BOULDER COUNTY PLANNING COMMISSION PUBLIC HEARING

STAFF RECOMMENDATION

Docket SU-20-0003: Jubilee Acres Reception Hall

Proposal: Special Use and Site Specific Development Plan request for a reception hall to host weddings and other events approximately 150 times per year on a 36-acre parcel.

COVER SHEET

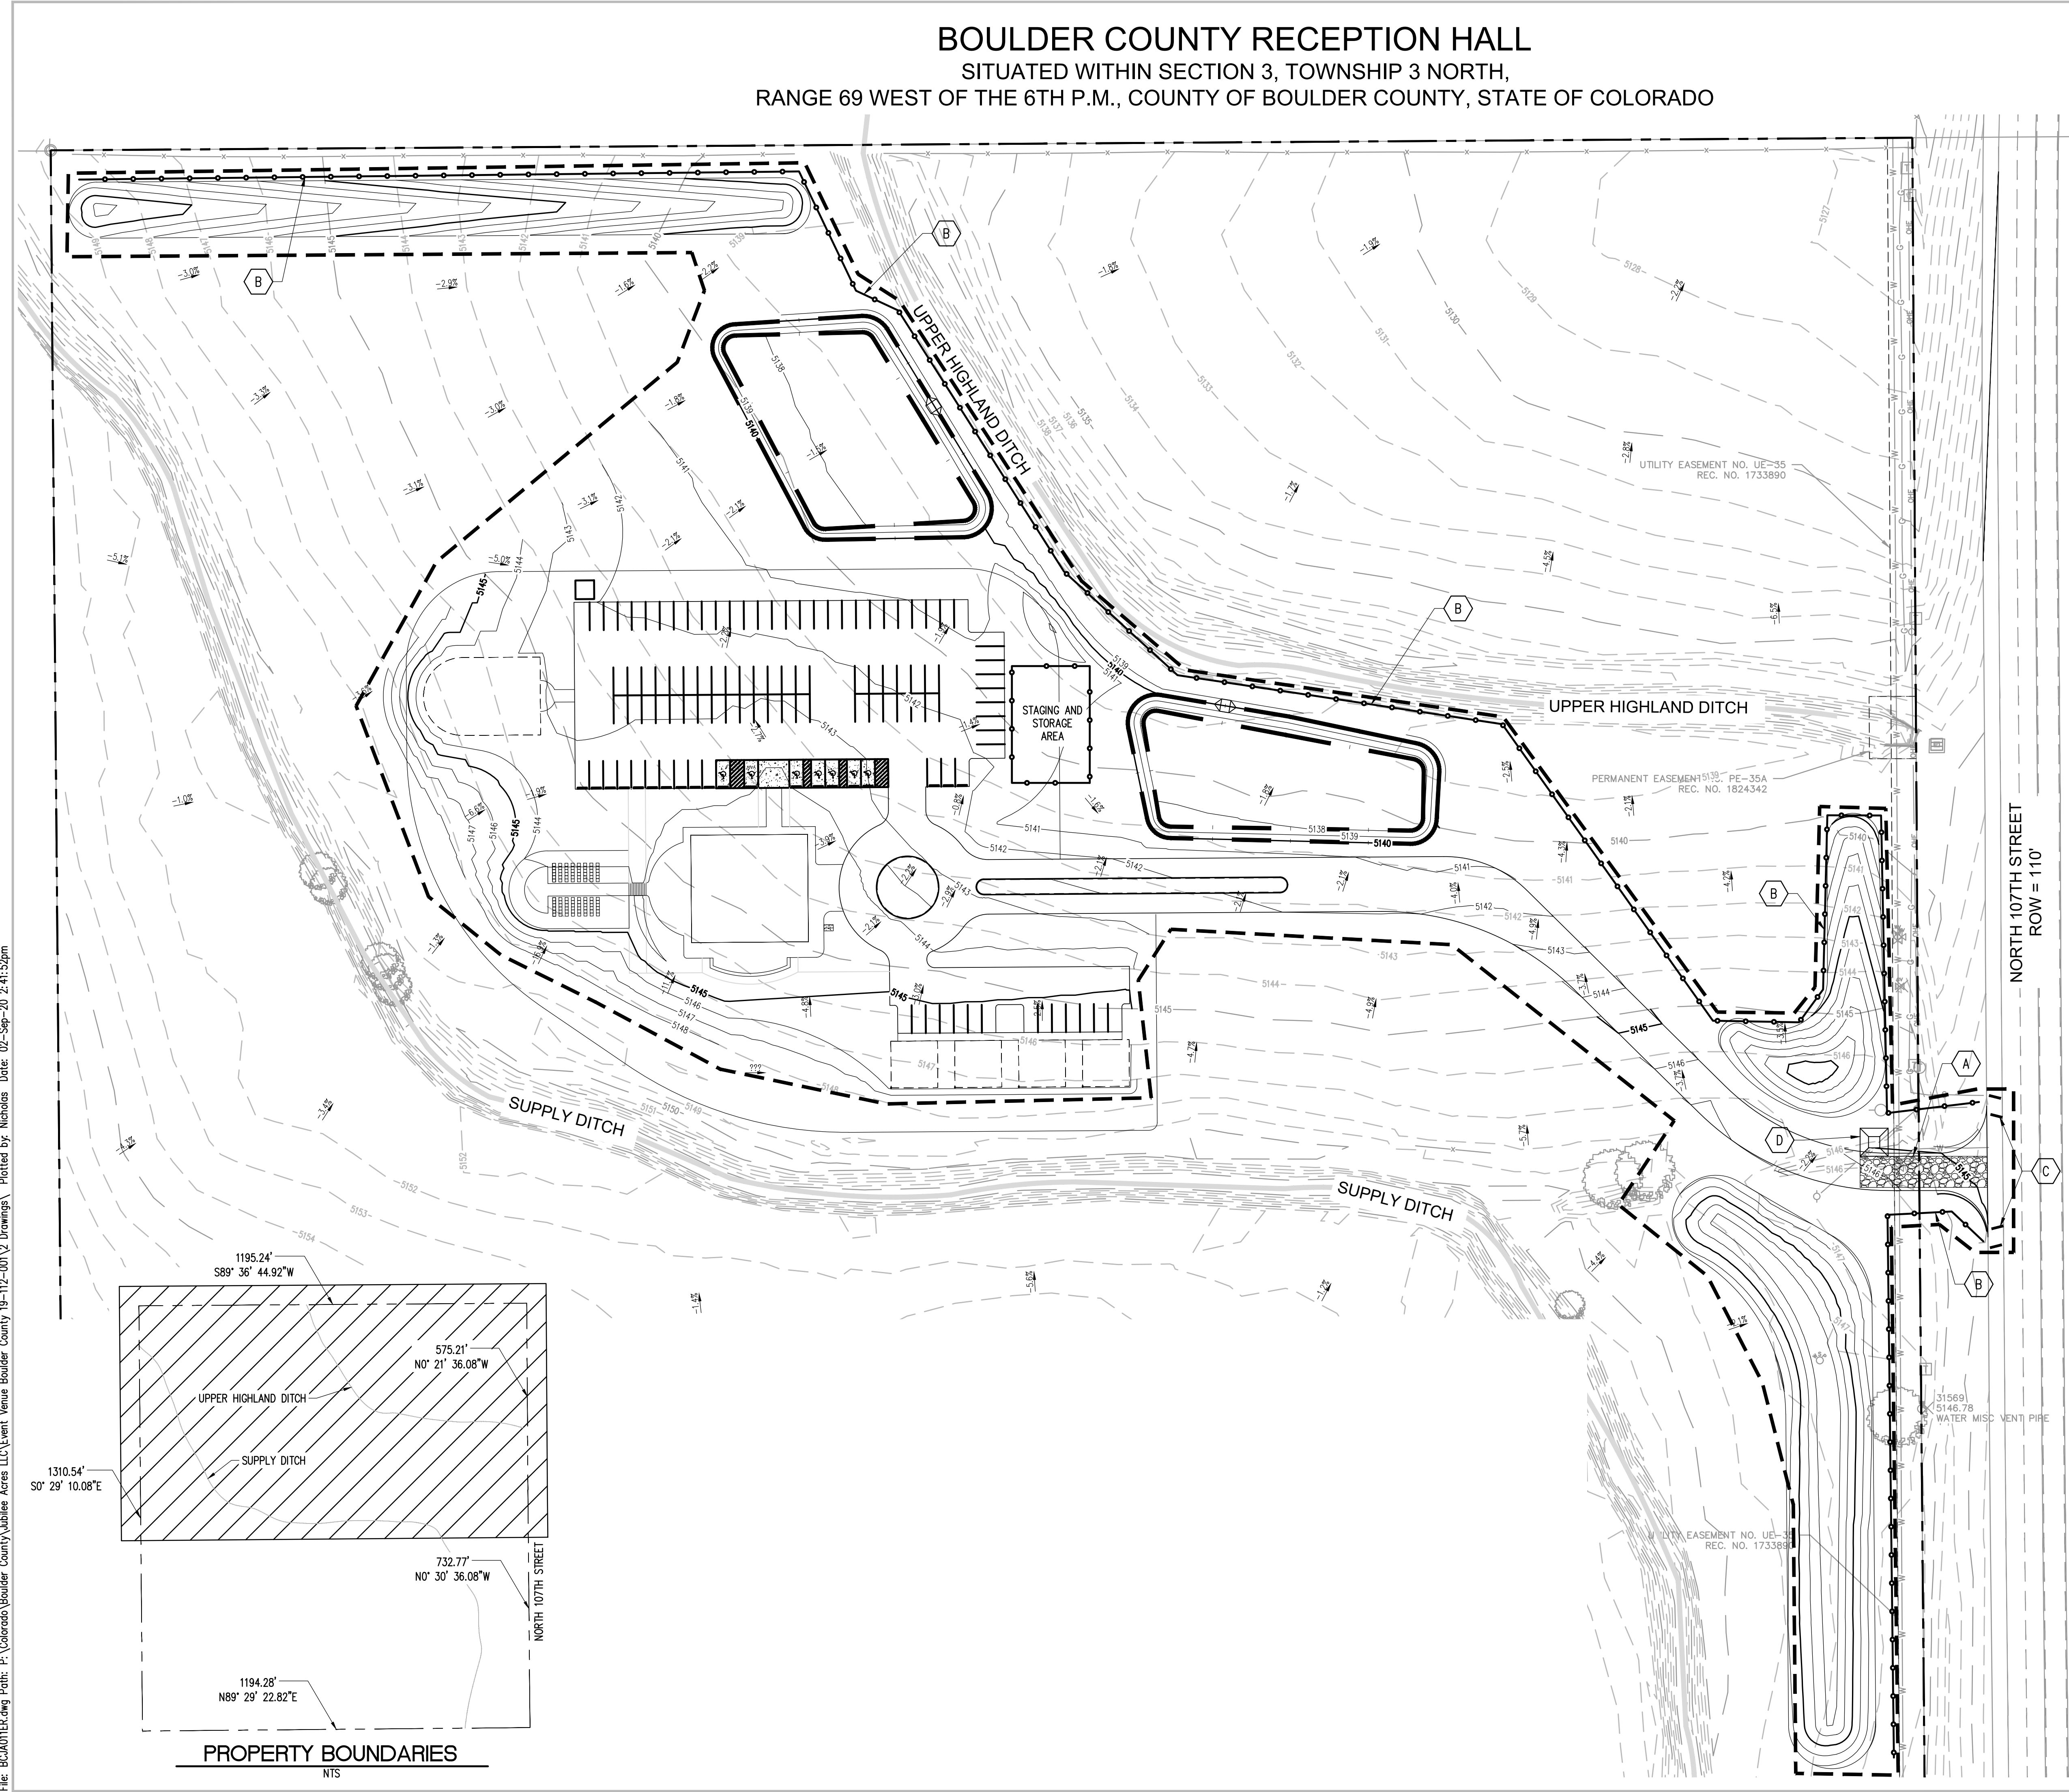
CV-1.0, Grading Note #4 – “All unsurfaced areas disturbed by grading operation shall receive 4 inches of topsoil.” All existing topsoils should be stripped and temporarily stockpiled, then replaced on disturbed areas. (Staff notes that Drawing LS-1.1 states that, “...topsoil that is removed during construction activity shall be conserved for later use.”

INTERIM EROSION CONTROL

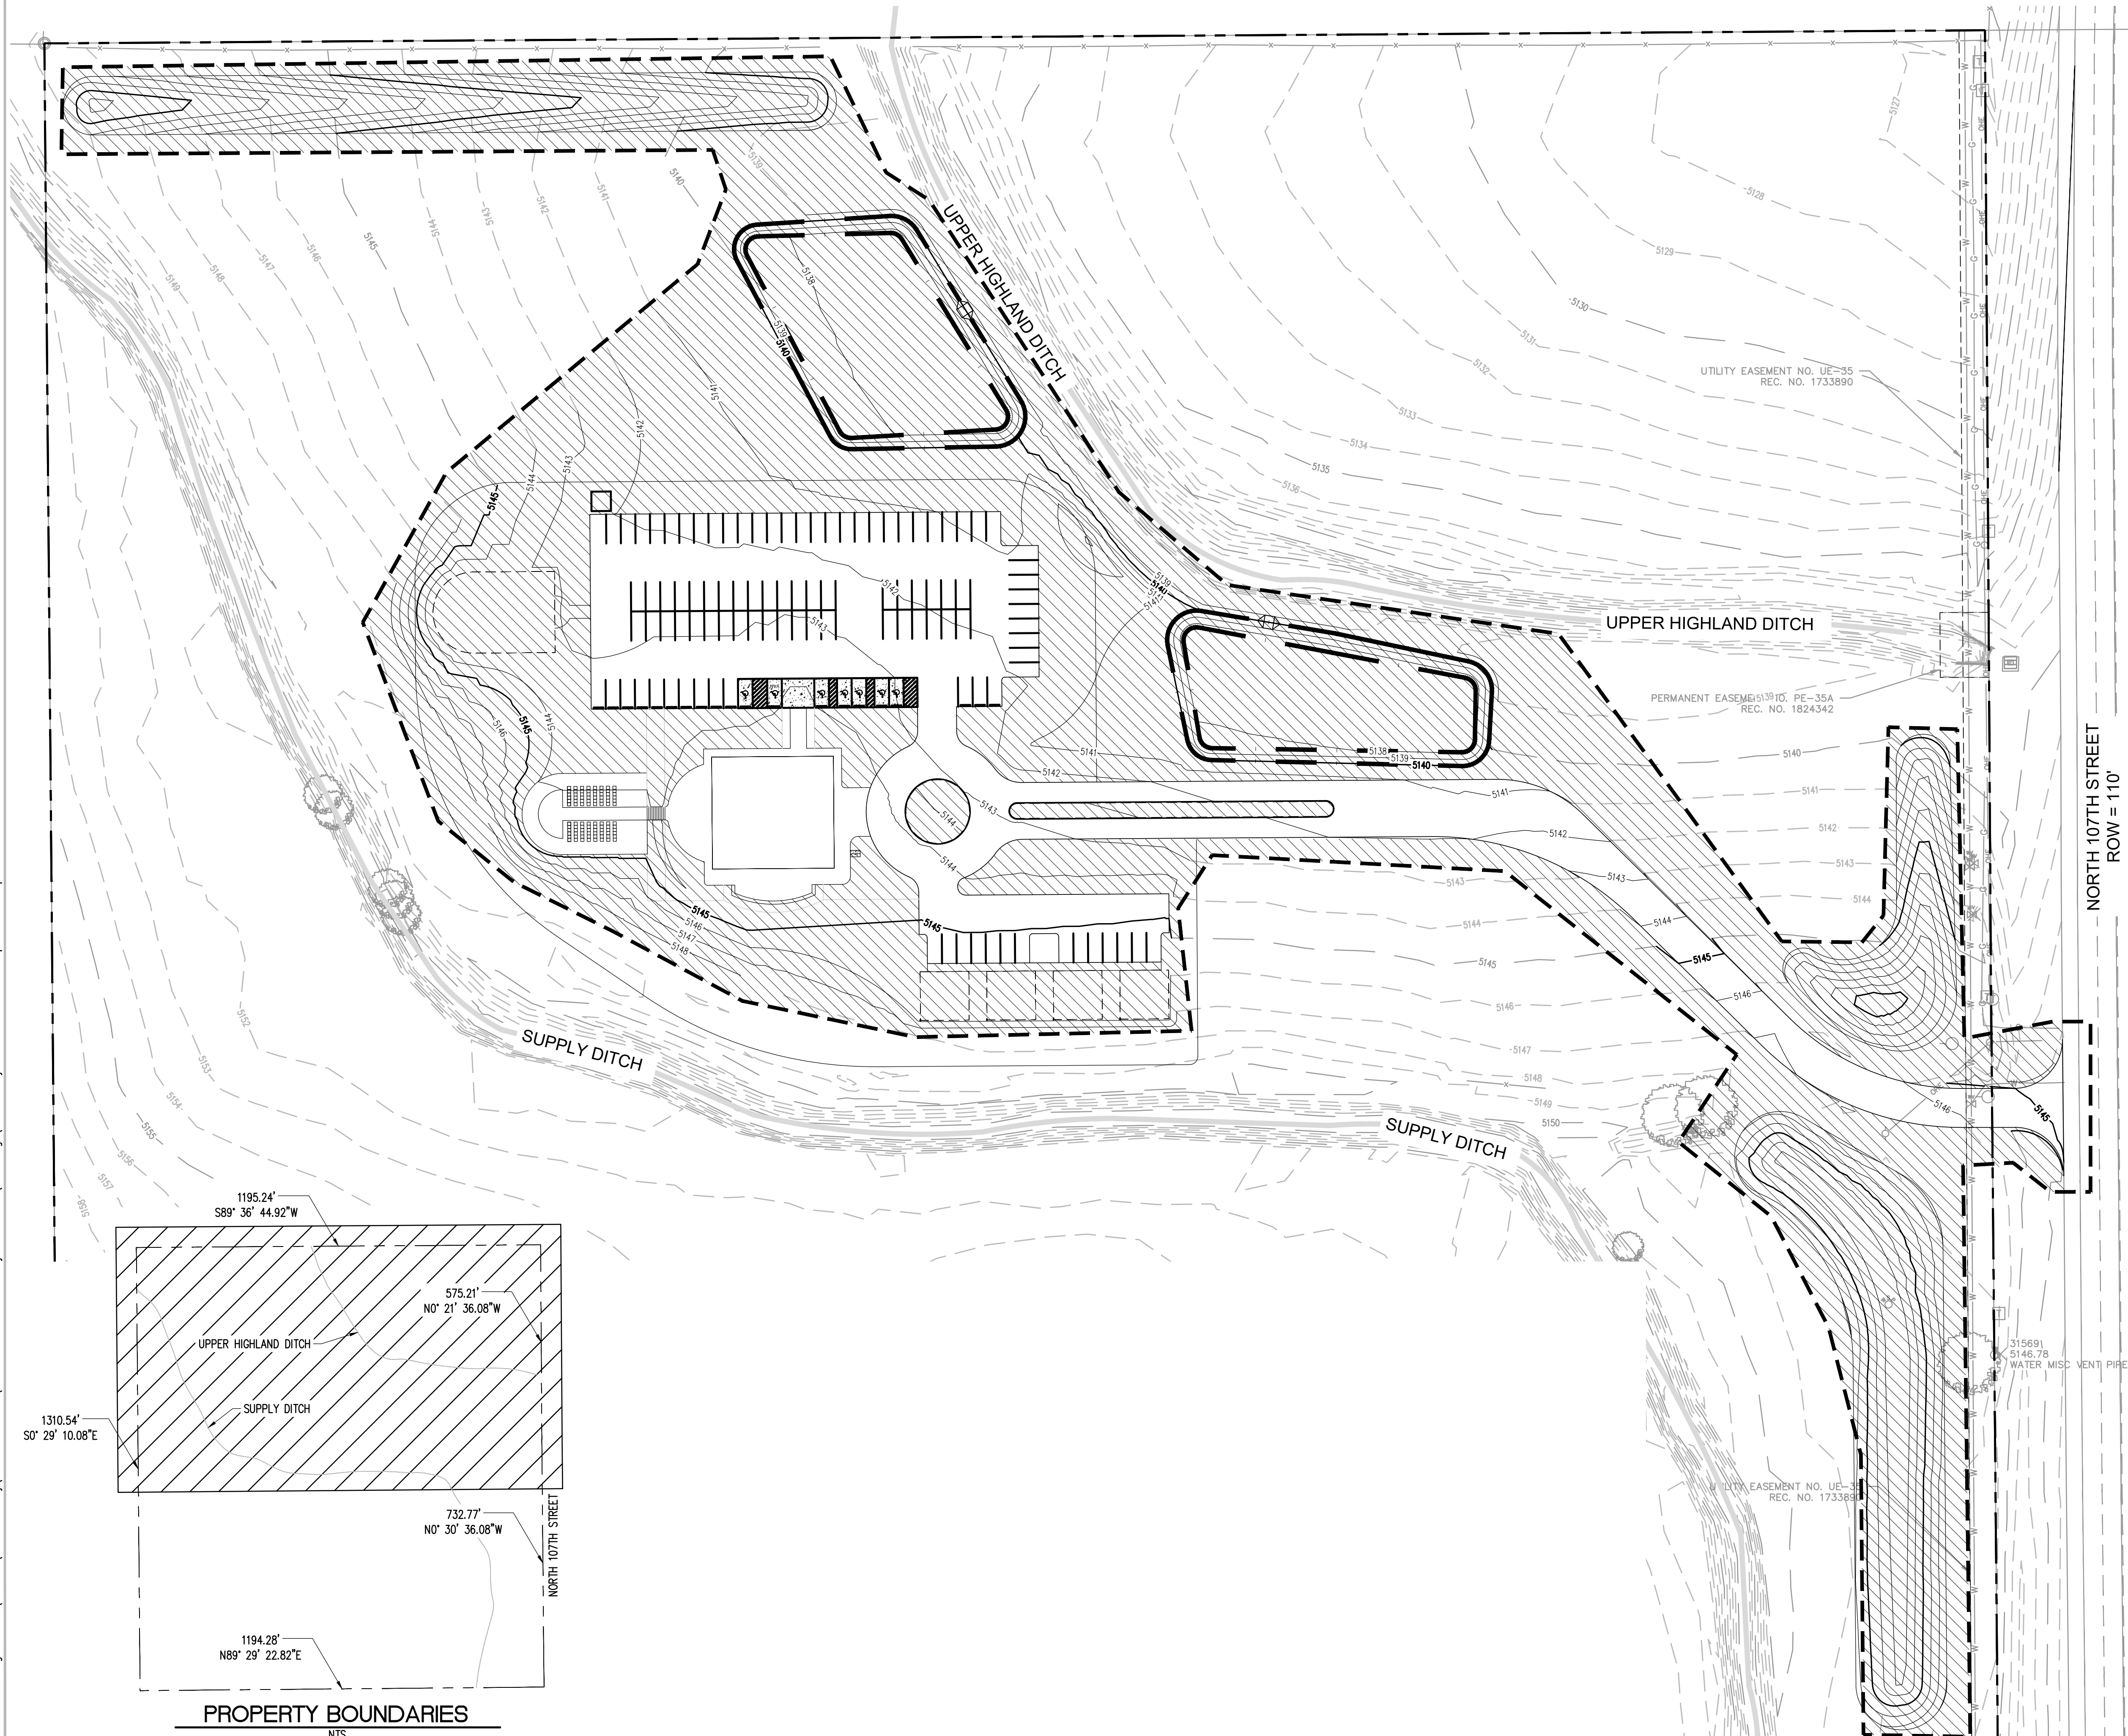
What is the total disturbance acreage, including future chapel, cabins, all parking, and grading for septic, landscaping, roads and circulation? Drawing ER-1.1 shows this to be 9.1 acres. If correct, this translates to 25 percent of the entire 36-acre parcel that would be, at least, disturbed for construction. From a parcel perspective, this would be a significant negative impact.

LANDSCAPE PLAN

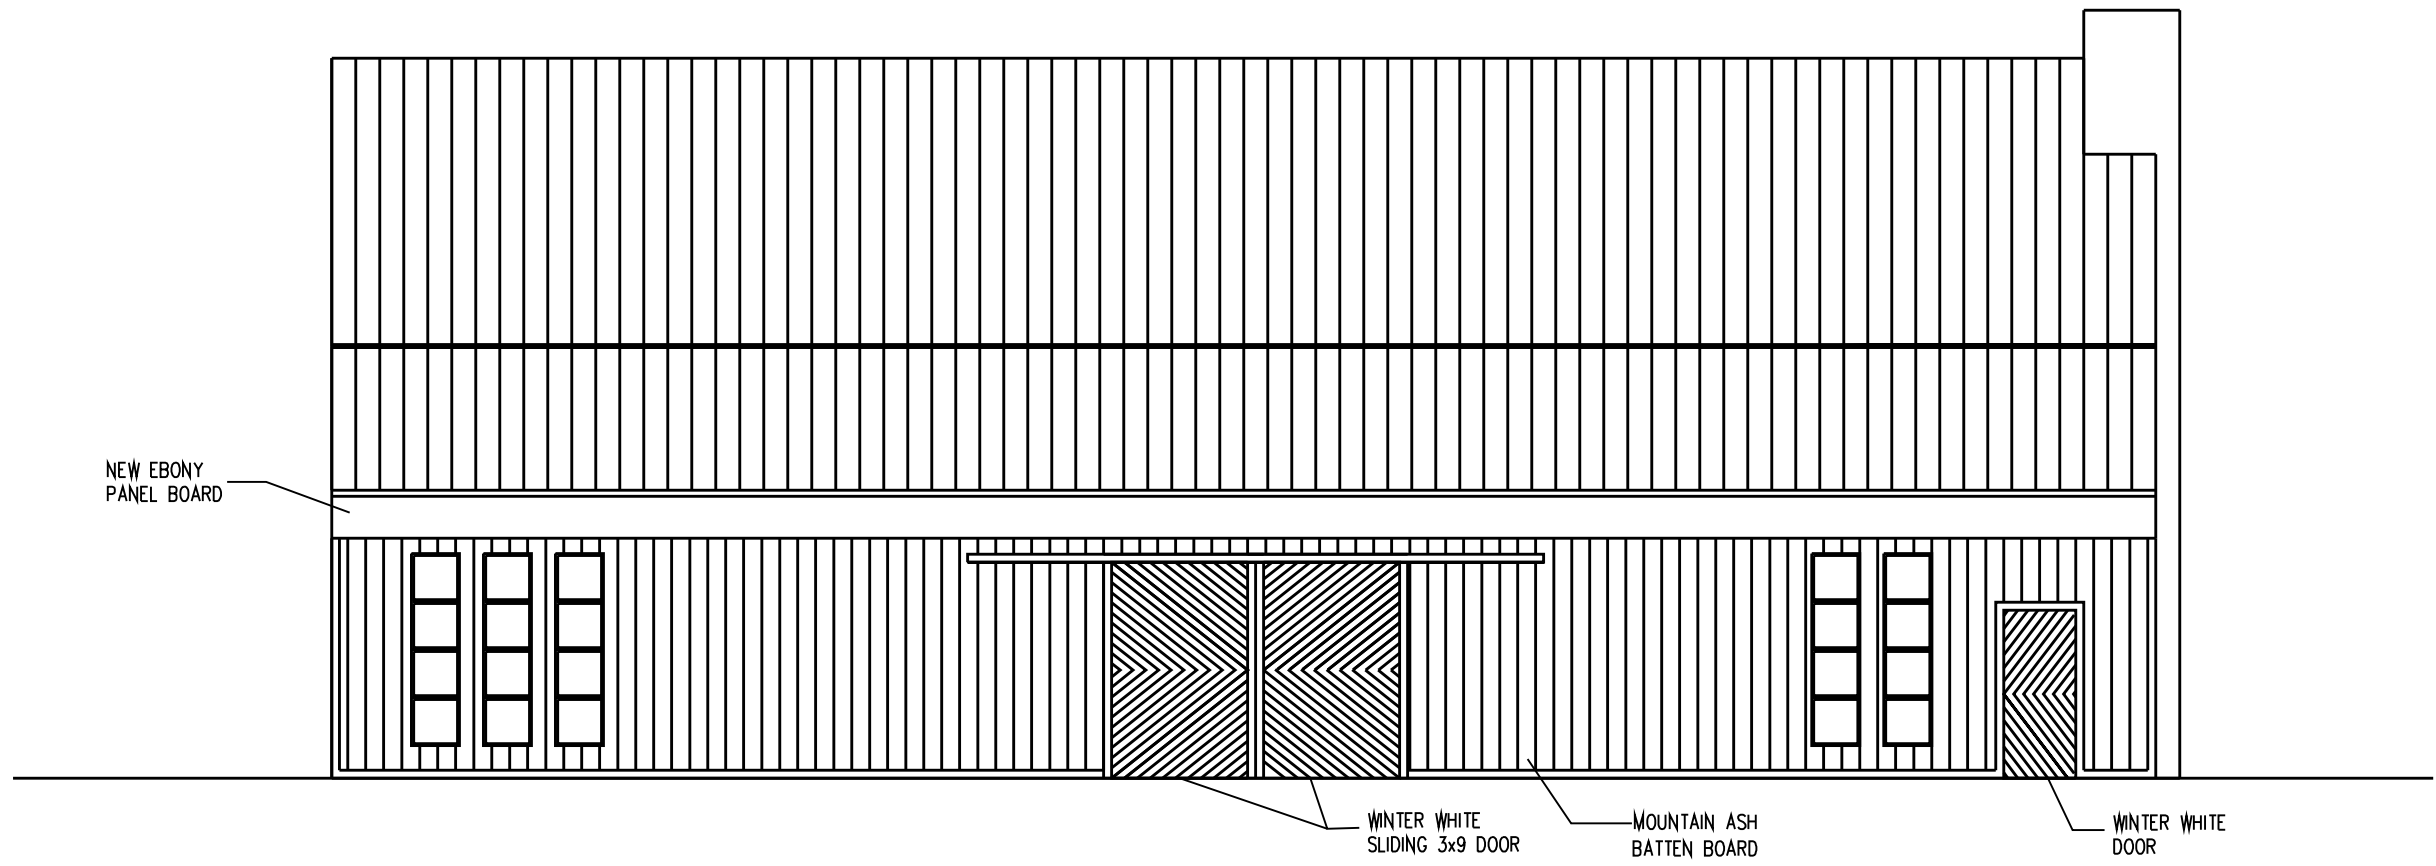
LS-1.0 – This drawing shows that the surfaces of the two retention ponds are to receive native grass seed. How would this vegetation in the ponds be managed, to keep them from becoming simply dusty basins?
